21023-02-001

**Proposed Residential Development at
Devoy Barracks, Naas**

**STAGE 1 QUALITY AUDIT
(incorporating an access, cycling, walking
and road safety audit)**

4.1 Issue:

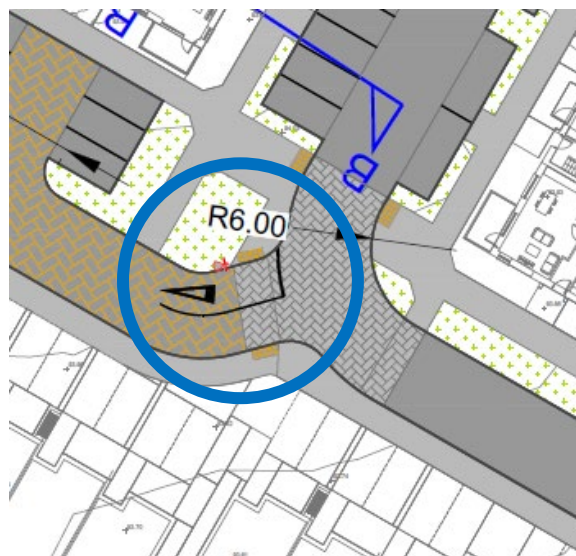
It is unclear if the internal road at the north eastern corner of the development has adequate width. Two vehicles may have difficulty in passing one another along this section of road, particularly at the changes in direction of the road alignment, which may contribute to a collision at this location.

Ensure that adequate two-way width is provided at this location to accommodate two-way flow of vehicles.

4.4 Issue:

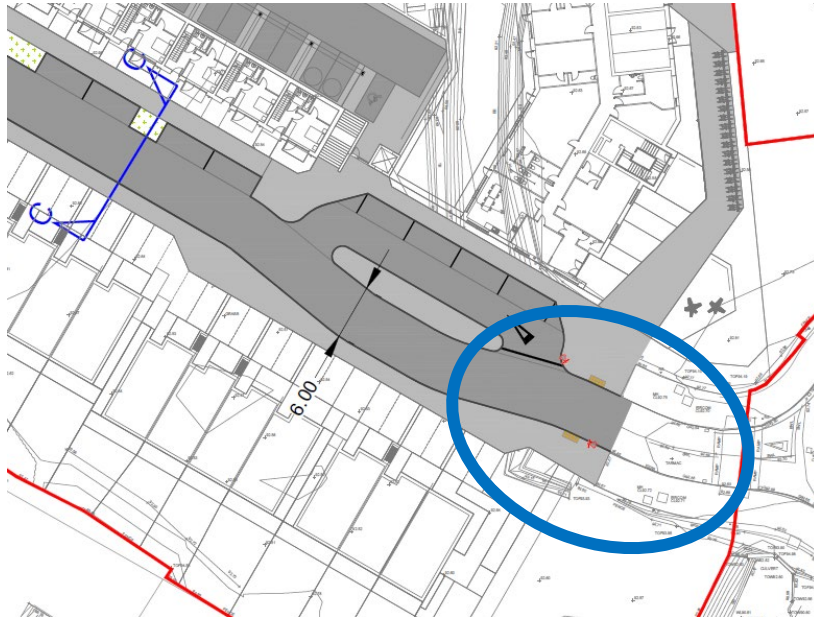
There is a number of low radius bends proposed along the development access roads. Two vehicles may have difficulty in passing one another on these bends which may lead to a side swipe collision. Stopping sight distance at the bends may also be restricted by the proposed parking, planting and boundaries on the inside of the bends.

Revise the layout at the bends to ensure that two vehicles can safely pass one-another, and that adequate stopping sight distance is provided.

4.6 Issue:

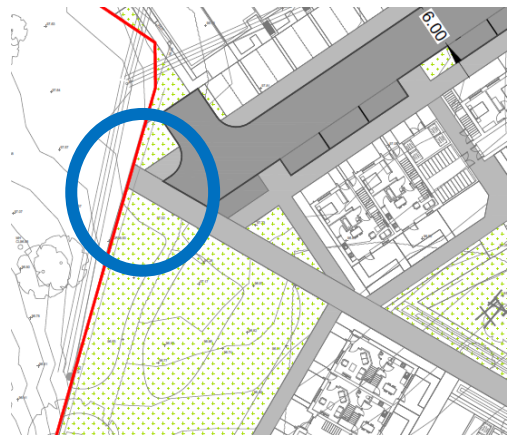
The proposed footpath within the development is shown to provide a link to the existing Arconagh housing estate which is located to the west of the proposed development. However, no details are provided to indicate how a pedestrian can safely access / egress the existing footpath within the Arconagh housing estate.

Provide an adequate footpath link from the proposed footpath within the Arconagh housing estate.

4.5	Yes	No	Existing signage and tactile paving etc is already constructed on the roundabout arm that confirm the cycletrack facilities have ended.	Yes
4.6	Yes	No	The future link is outside lands in the ownership of the developer. Completion of this link shall be agreed with the Local Authority prior to commencement of the development following a favourable grant of planning.	Yes

4.7 Issue:

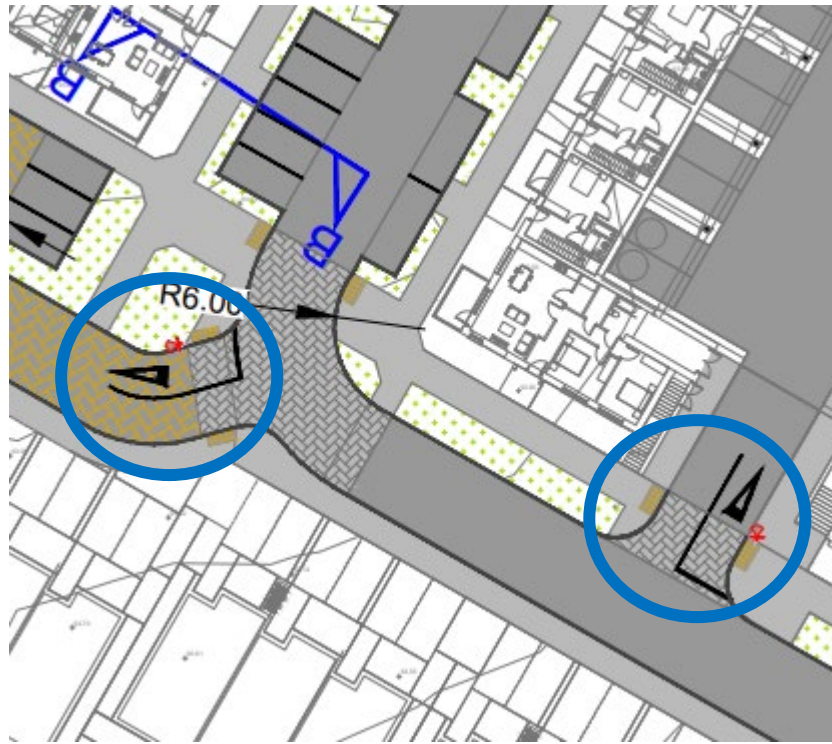
There are a number of locations where pedestrian crossing facilities such as dropped kerbs and tactile paving are not shown to be provided to cater for the desired route for pedestrians. A lack of pedestrian connectivity may increase collision risk within the proposed development.

Ensure adequate crossing facilities are provided to cater for the desired route for pedestrians throughout the proposed development.

4.13 Issue:

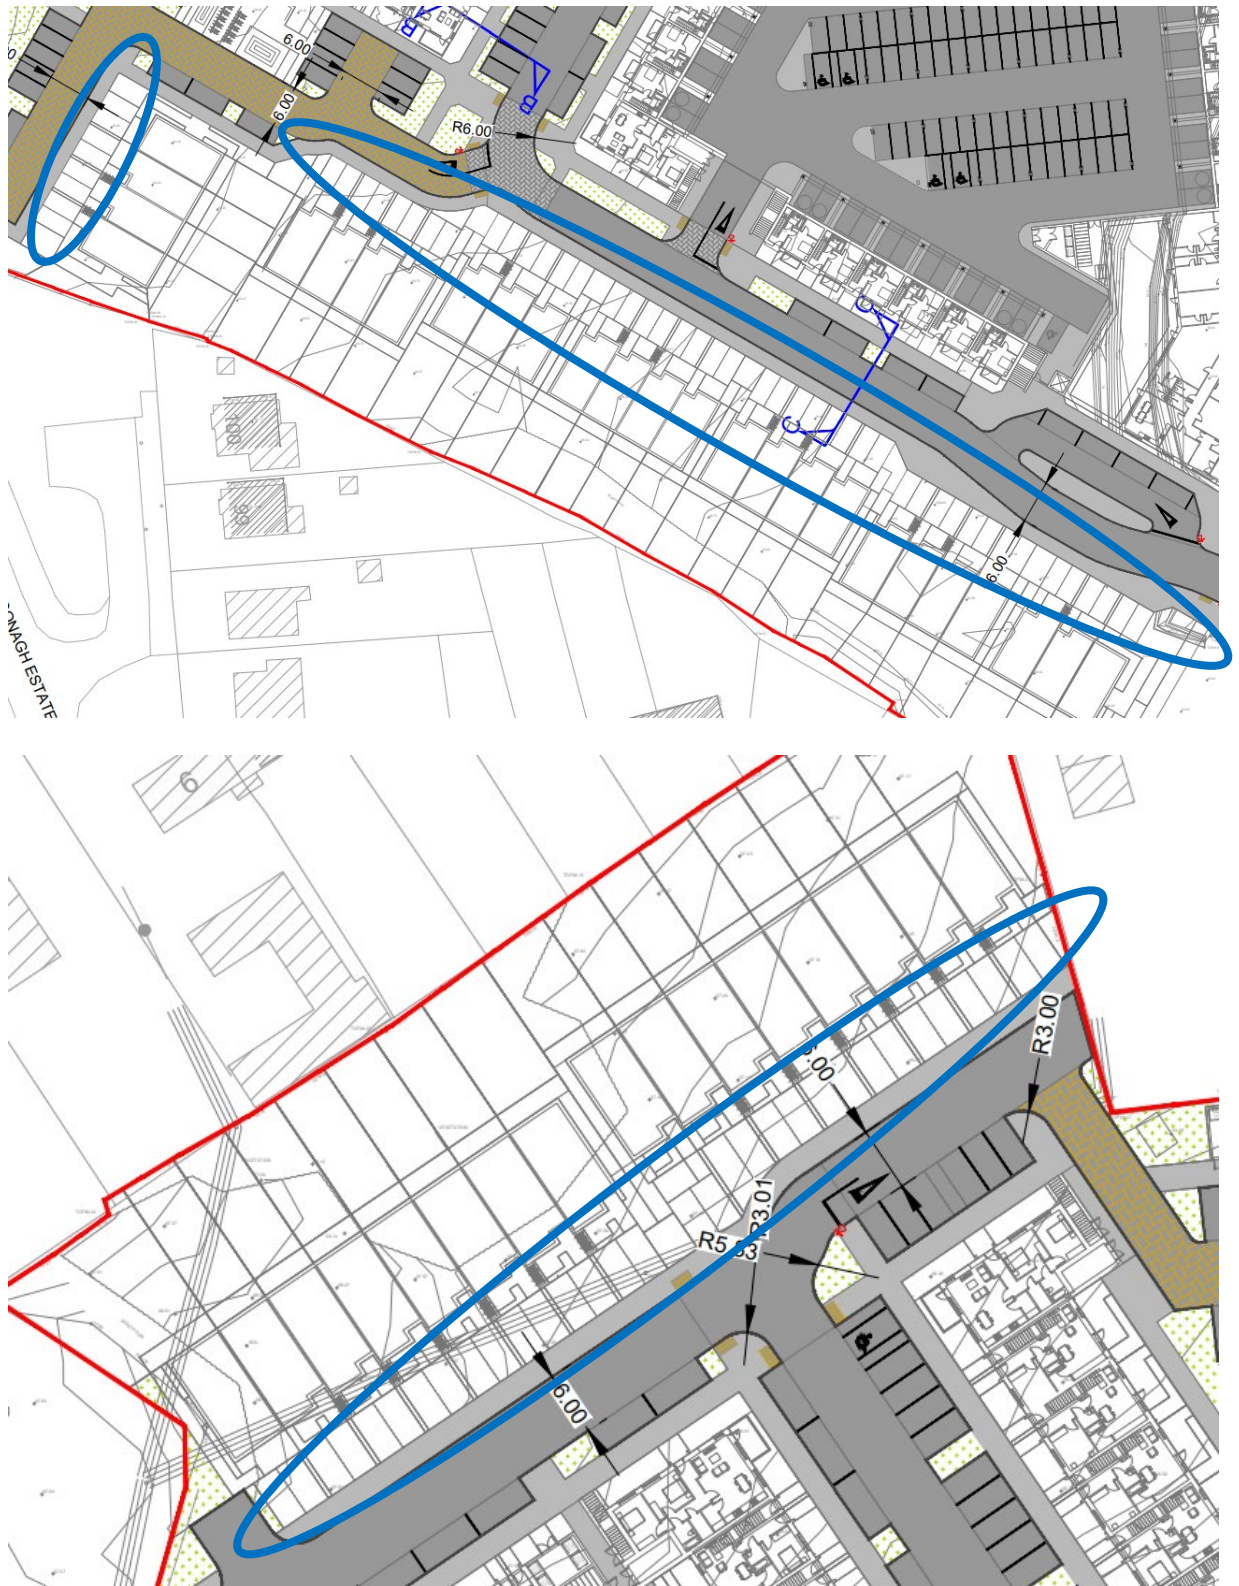
Visibility splays for drivers of vehicles at a number of junctions may be restricted by vehicles parked in adjacent car parking spaces. A lack of adequate visibility may contribute to a collision at these locations.

Ensure that adequate visibility splays are provided at all junctions within the proposed development.

4.16 Issue:

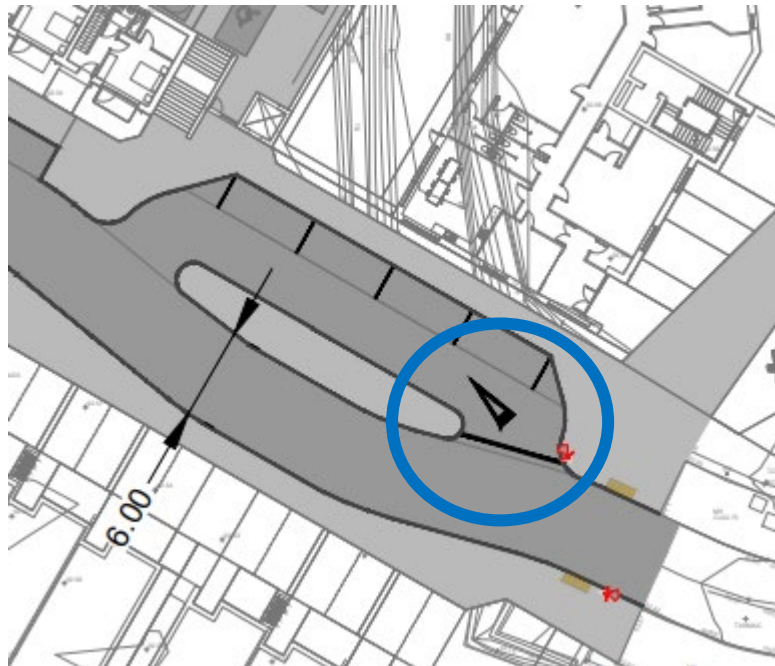
A number of disabled parking spaces are shown to be provided within the proposed development. However, it is unclear whether mobility impaired pedestrians can safely access these parking spaces.

Provide appropriate dropped kerbs and tactile paving to allow mobility impaired pedestrians to safely access these parking spaces.

4.19 Issue:

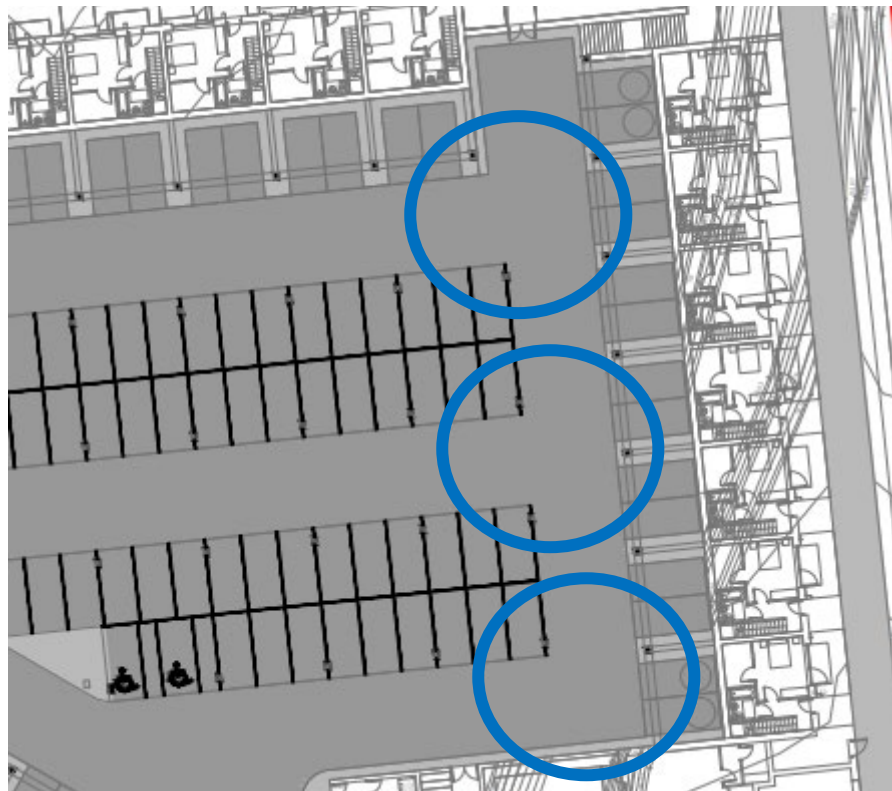
Visibility splays for drivers of vehicles at a number of internal junctions within the undercroft carpark may be restricted by vehicles parked in adjacent car parking spaces. A lack of adequate visibility may contribute to a collision at these locations.

Ensure that adequate visibility splays are provided at all of the internal junctions within the undercroft carpark.
